**THIS BULLETIN IS FAA APPROVED FOR ENGINEERING DESIGN**

SUBJECT: Mooney Windscreen and Window Fastener Installation Procedure

MODELS/ SN  
AFFECTED: M20U Ovation Ultra - 32-0002  
M20V Acclaim Ultra - 33-0002 and 33-0003

Figure SB M20-329-1 - Hole Placement Around Outboard Perimeter of Windscreen

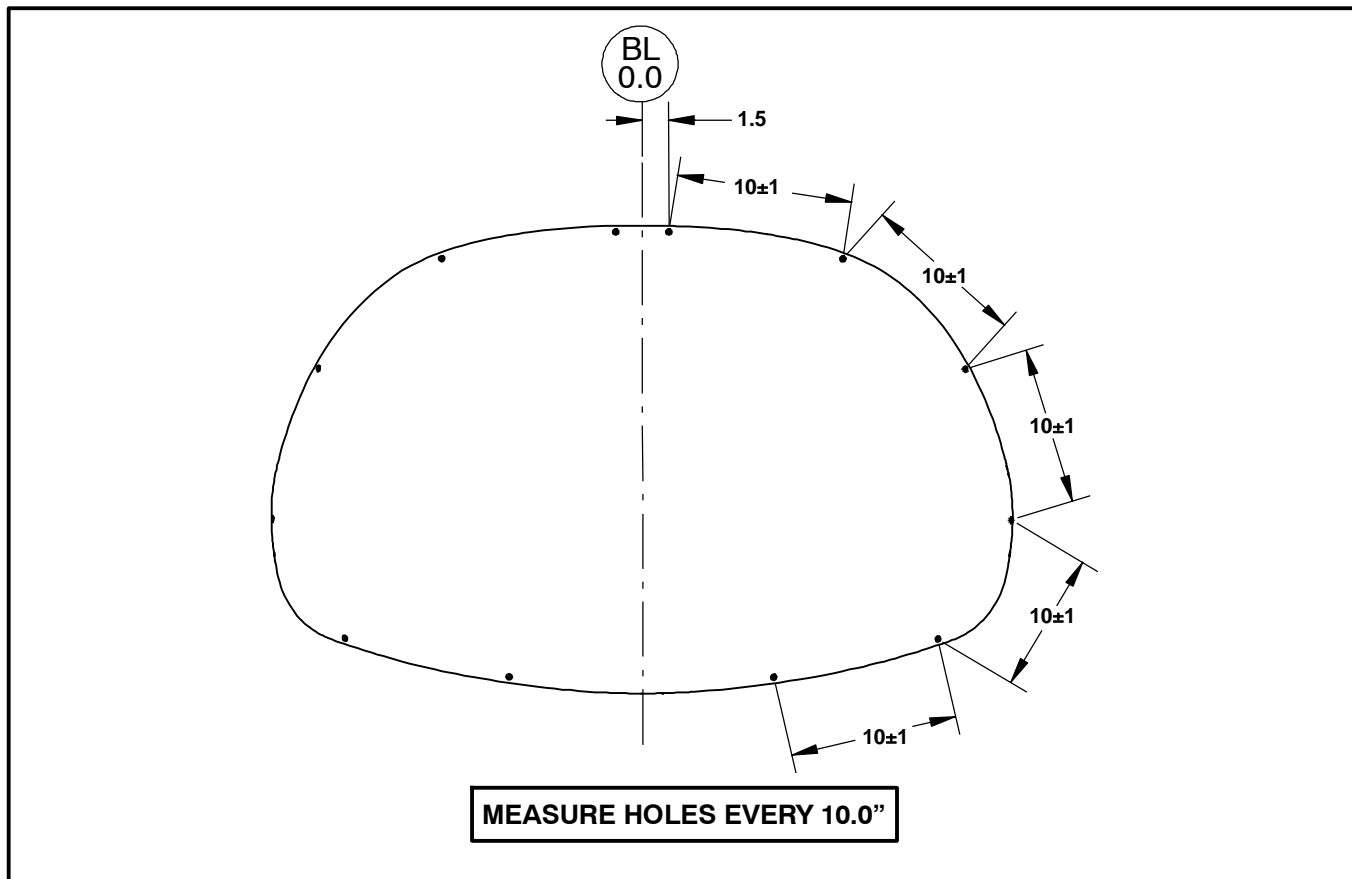
- 1.1. Remove upper and front post interior panels and glare shield from aircraft. Refer to the applicable Mooney Service and Maintenance Manual.
- 1.2. Starting from center butt line at the outboard top of the windscreen, measure 1.5 inches to the right and mark the first hole using masking tape or a similar method.

- Be a minimum distance of 0.75" from the rivet spacer in the shell flange.
- Be a minimum distance of 0.30" from the edge of the windscreen and flange.

Continue measuring around the outboard perimeter of the windscreen, marking off 5 additional holes every 10 inches. Refer to Figure M20-329-1.

- 1.3. Repeat step 1.2 to the left of the center butt line starting at the outboard top of the windscreen. A total of 12 holes should be marked off.
- 1.4. Using a BAT #40 HSS drill bit and a drill guide, carefully drill the 12 holes around the outboard perimeter of the windscreen and shell flange. Refer to Figure M20-329-3.

Figure SB M20-329-2 - Hole Placement Around Outboard Perimeter of Windows (LH Shown)

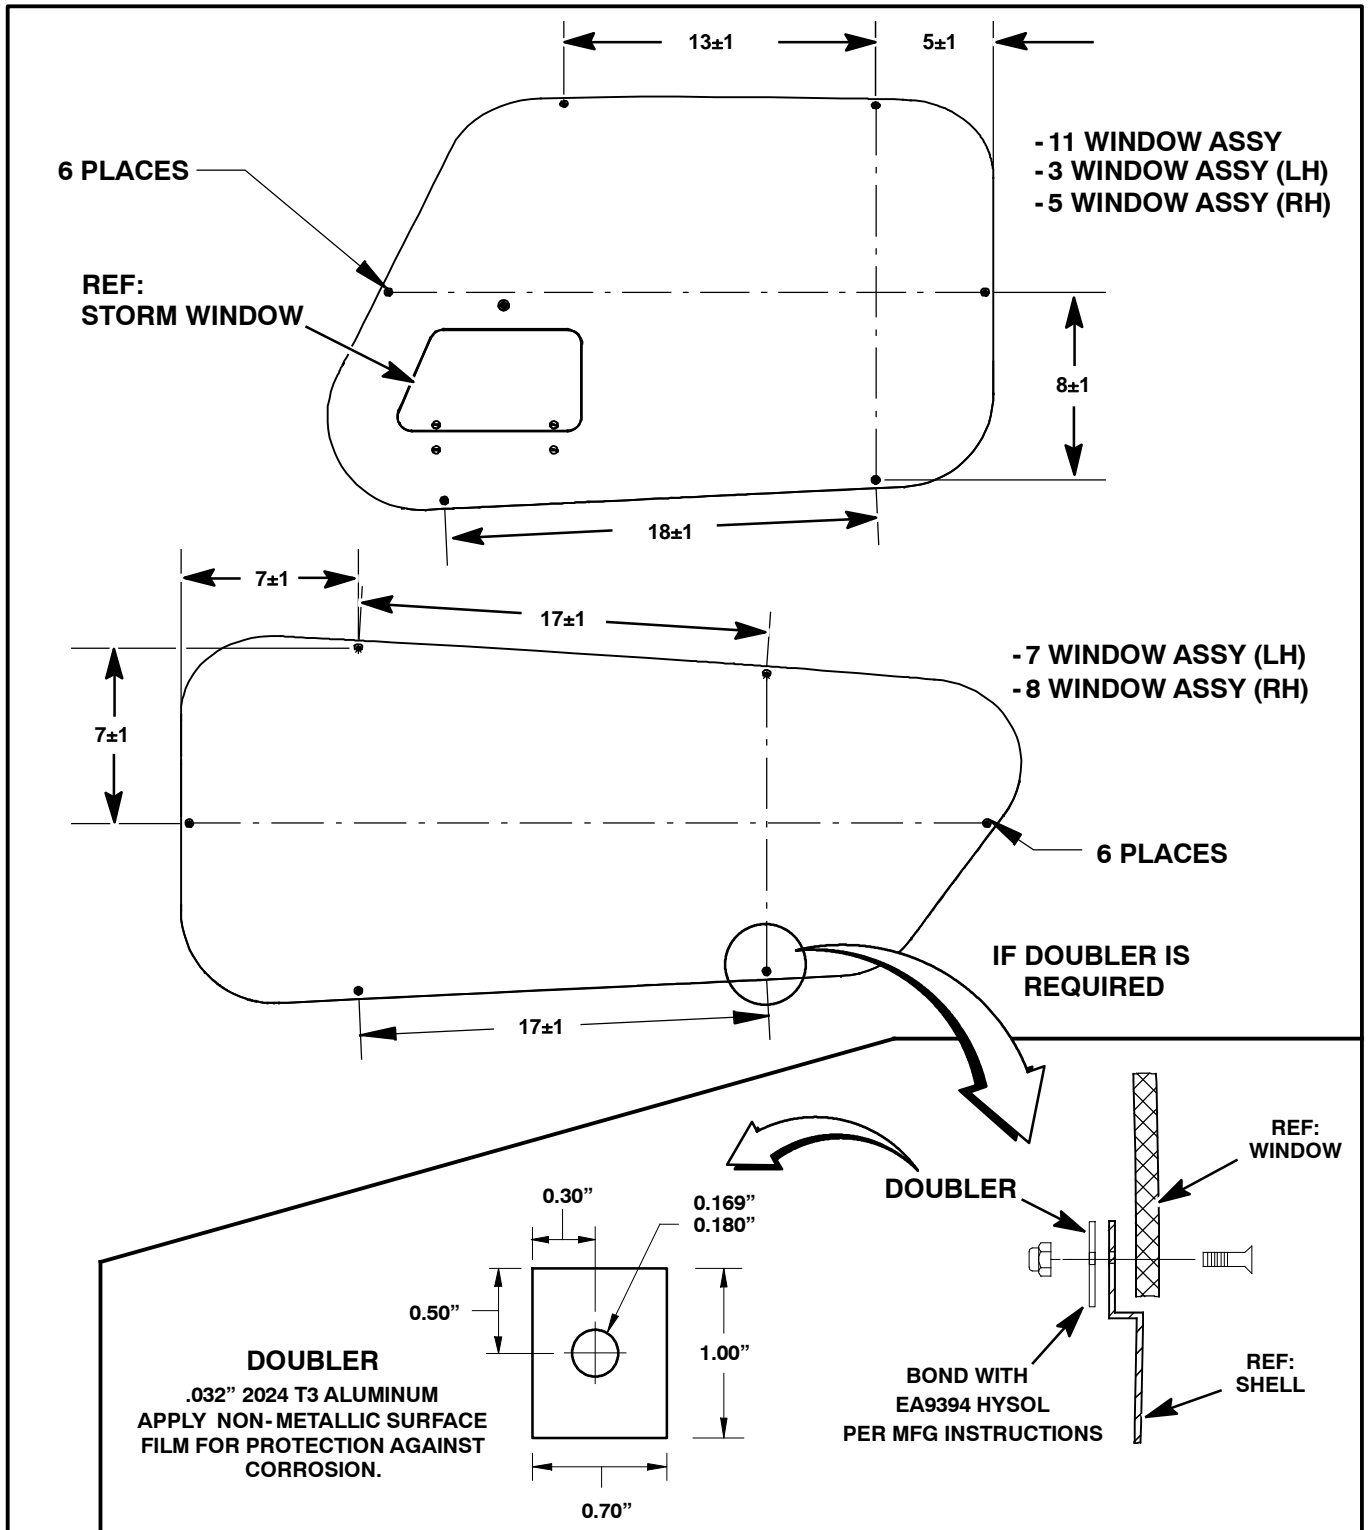
- 2.5. Using masking tape or a similar method, measure and mark the hole locations on the window. A total of 6 holes should be marked off per window. Refer to Figure M20-329-2 for hole locations and measurements.

- Be a minimum distance of 0.750" from the rivet spacers in the shell flange.
- Be a minimum distance of 0.300" from the edge of the window and flange.

- If edge distance is between 0.200" - 0.300" from the edge of the composite shell flange, a doubler will be required.
- Anything less than 0.300" on window or 0.200" on composite flange is unacceptable and will need further action from Mooney International.

- 2.5.1 If doubler is required, make from 0.032" thick 2024 T3 Aluminum and cut to 1.00" x 0.700" size, refer to Figure M20-329-2. Apply a non-metallic surface film (Chemical Conversion Coating) to doubler for protection against corrosion.
- 2.5.2 Bond doubler to inner window flange with EA9394 Hysol per manufacturers instructions and located such that the fastener hole is at least 0.300" from the edge of the doubler.

Figure SB M20-329-3 - Drill Bit Sequence

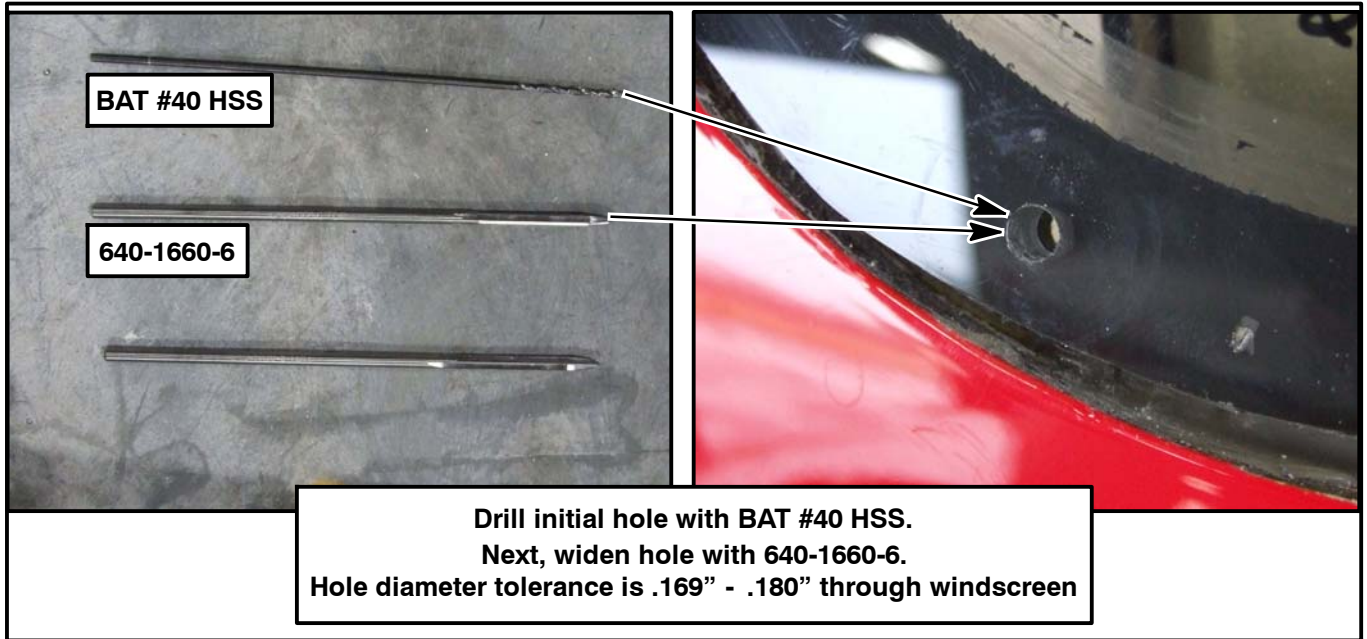
- 1.5. Using a 640-1660-6 drill bit and a drill guide, carefully enlarge the holes. Refer to Figure M20-329-3. Hole diameter tolerance is .169" - .189" through windscreen.

- 2.6. Using a BAT #40 HSS drill bit and a drill guide, carefully drill the 6 holes around the outboard perimeter of the window and shell flange. Refer to Figure M20-329-3.

- 2.7. Using a 640-1660-6 drill bit and a drill guide, carefully enlarge the holes. Refer to Figure M20-329-3. Hole diameter tolerance is .169" - .189" through windscreen.

Figure SB M20-329-4 - Drill Bit Sequence

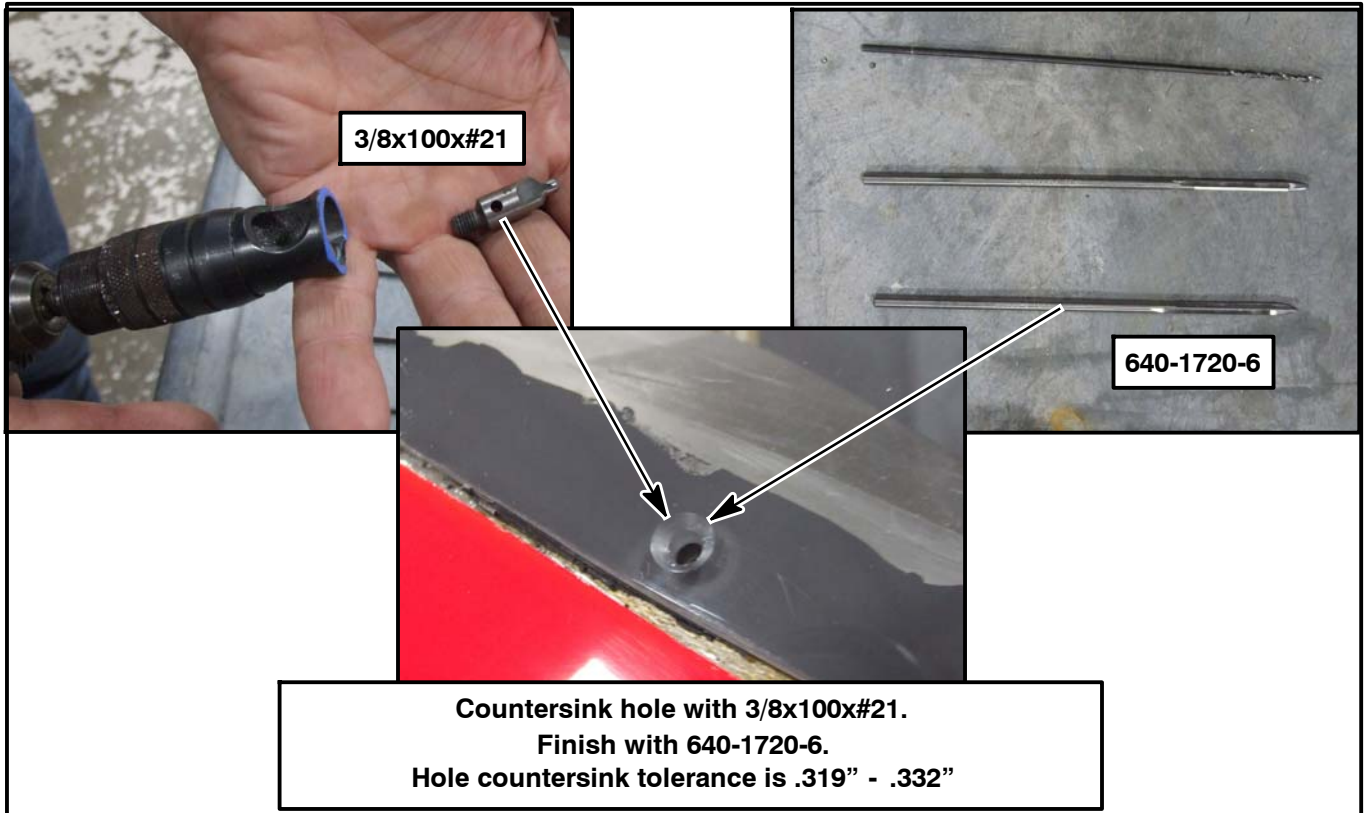
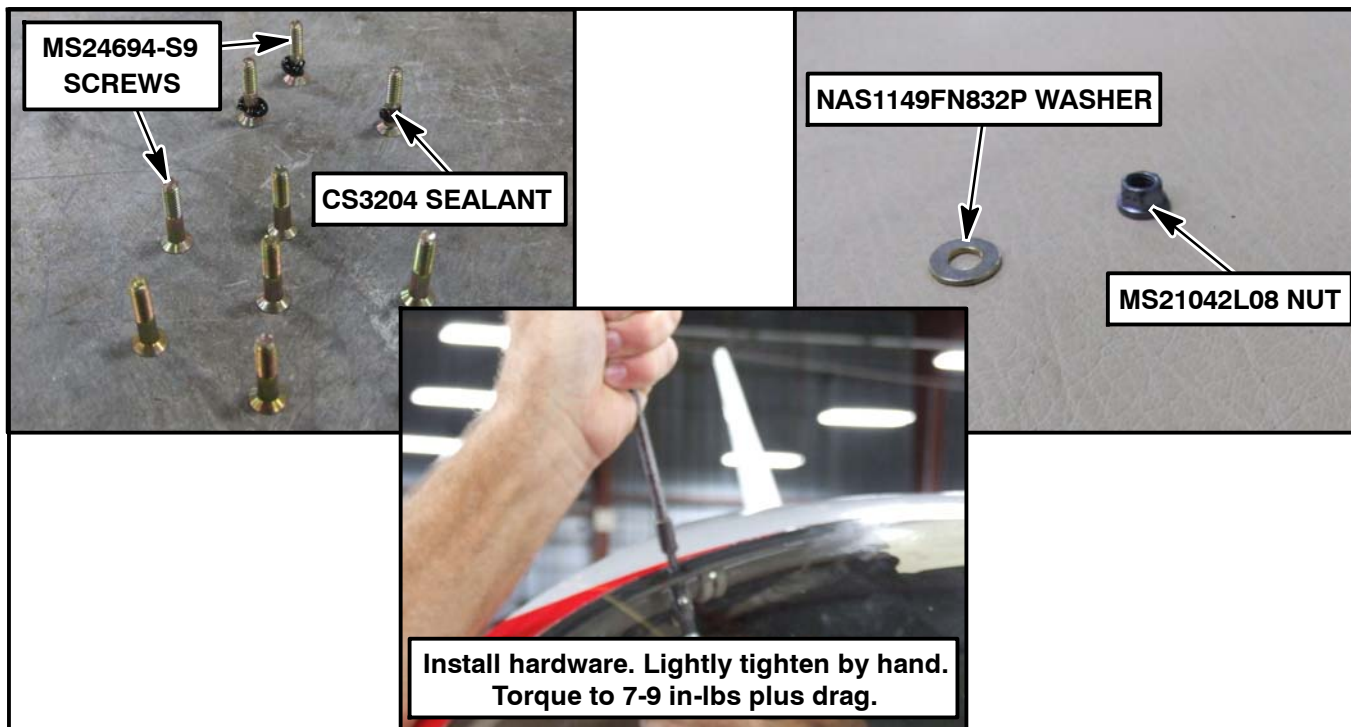
- 1.6. Using a 3/8x100x#21 countersink drill bit, carefully countersink the holes. Refer to Figure M20-329-4. Hole countersunk tolerance is .319" - .332" through windscreen.
- 1.7. Using a 640-1720-6 drill bit, carefully enlarge the holes. Refer to Figure M20-329-4.
- 1.8. Inspect the holes for signs of crazing, cracking, or chipping. If these signs are present, stop procedure and contact Mooney Technical Support.
- 1.9. Place a small bead of CS3204-B sealant around the underside of the head of the MS24694-S9 screws. Refer to Figure M20-329-5.
- 1.10. Using a Phillips head screwdriver, install the MS24694-S9 screws, the NAS1149FN832P washers, and MS21042L08 nuts, and lightly tighten by hand. Refer to Figure M20-329-5.
- 1.11. Lightly tighten the screws until snug to <3 in-lbs.

- 2.8. Using a 3/8x100x#21 countersink drill bit, carefully countersink the holes. Refer to Figure M20-329-4. Hole countersunk tolerance is .319" - .332" through windscreen.

- 2.9. Using a 640-1720-6 drill bit, carefully enlarge the holes. Refer to Figure M20-329-4.
- 2.10. Inspect the holes for signs of crazing, cracking, or chipping. If these signs are present, stop procedure and contact Mooney Technical Support.
